DCN No. E000492-00-D

DOCUMENT CHANGE NOTICE (DCN)

DOCUMENT No. (DOC-REV-GP. ID)	TITLE	NEW REV.
D960004-A-D	Tower Base	B

REASON FOR CHANGE: This change is valid only for the LHO 2k IFO curved Mode Cleaner Mirror (MC2).

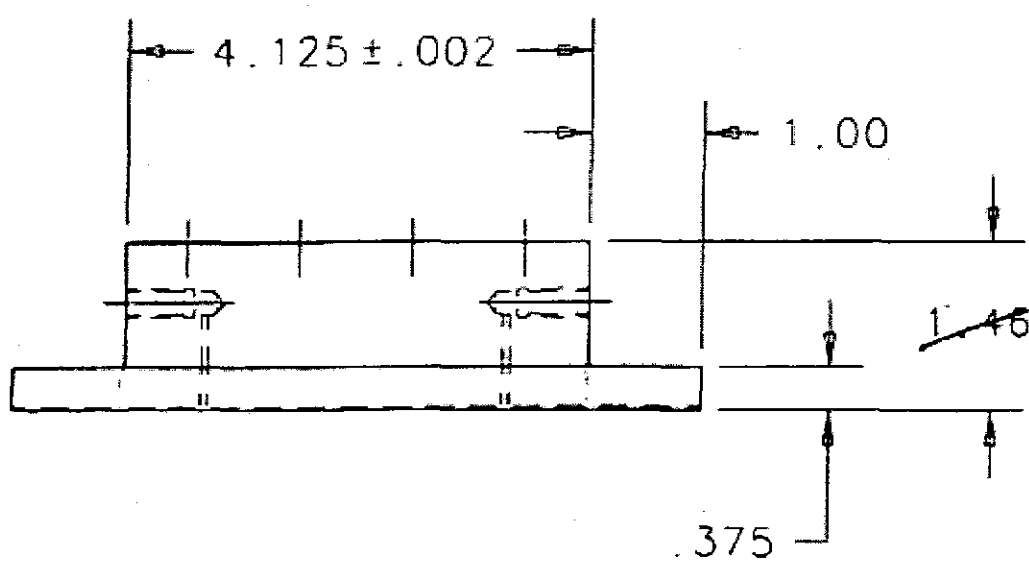
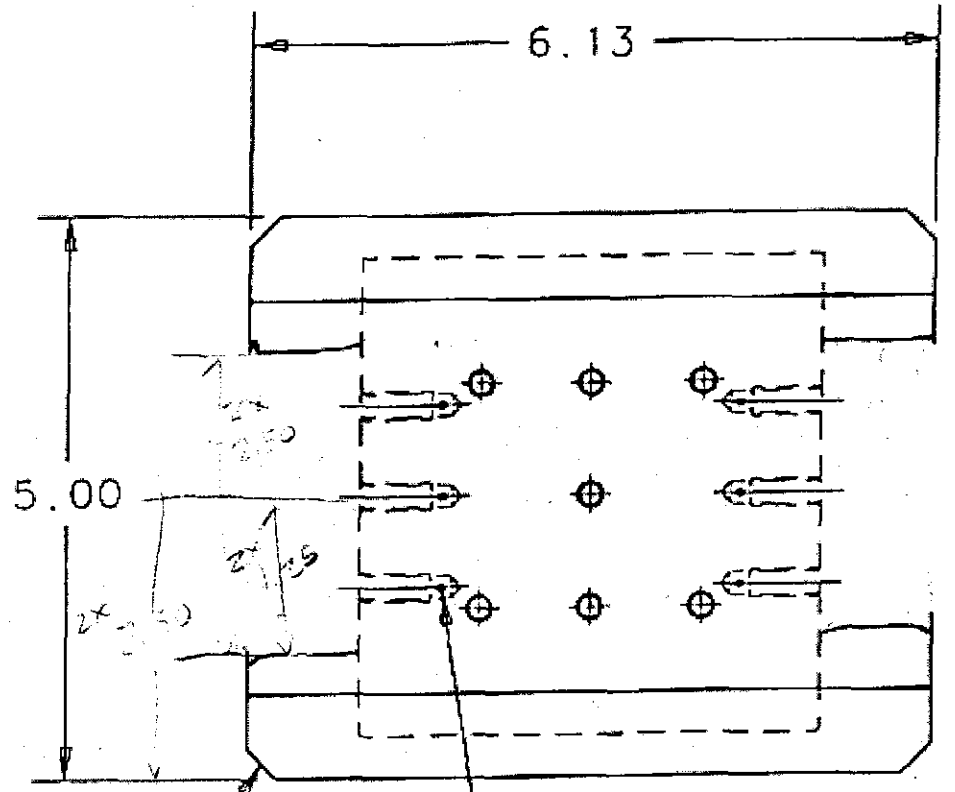
CHANGE DESCRIPTION (FROM/TO): Add cutouts in the bottom flanges. Add dimensions of cutout: 2X, 2.50, 2X, 2.50 and 2X, 1.25.
 zone D2, From 1.469 to 1.154
 zone C2, From 6X, .562 to 6X, .247

6X, ~~.502~~
.247

~~1.469~~ 1.154

It's not possible to shave 8 mm (0.315") off the bottom of the base and
have any strength left in the 0.375" thick flange that forms the foot and
clamp surface for the suspension. It is possible, I think, to cut away the
base flange and lower the attachment holes where the side plates screw into
the base by the necessary amount. The side plates will still be about
0.060" above the table. See the attached sketch, in gif and pdf form. I've
cut the height of the block down too, so the side plates overlap in a
similar way to the standard suspension.

After making the sketch I looked at the 2kglobals and realized that
WHAM7 is 8.5 mm lower (compared with local level) than WHAM8, not 8 mm, so
everything will need to be dropped an additional 0.020" (1.154->1.134,
.247->.227, and .622->.602) The distance from the attachment holes to the
bottom of the side plates is .562, so there is .040 between the bottoms of
the side plates and the table.

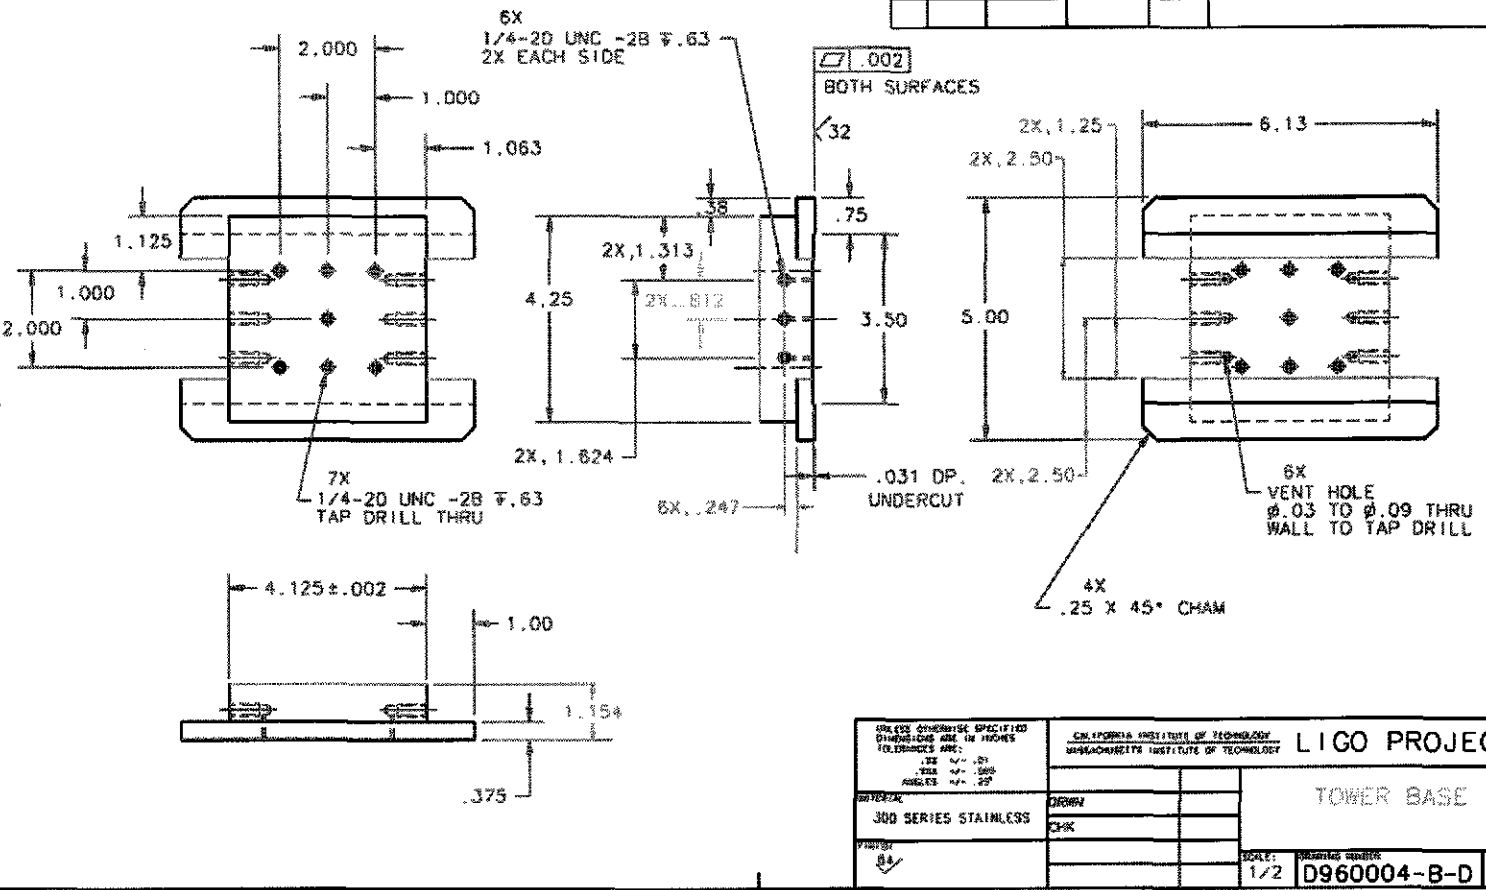
REV	DATE	BY	APP'D	DESCRIPTION
A	7-28-97	J. Hazel		E970121/INITIAL RELEASE
B	1-10-01	J. Romie		E000492/CUTOUTS FOR LMO2s
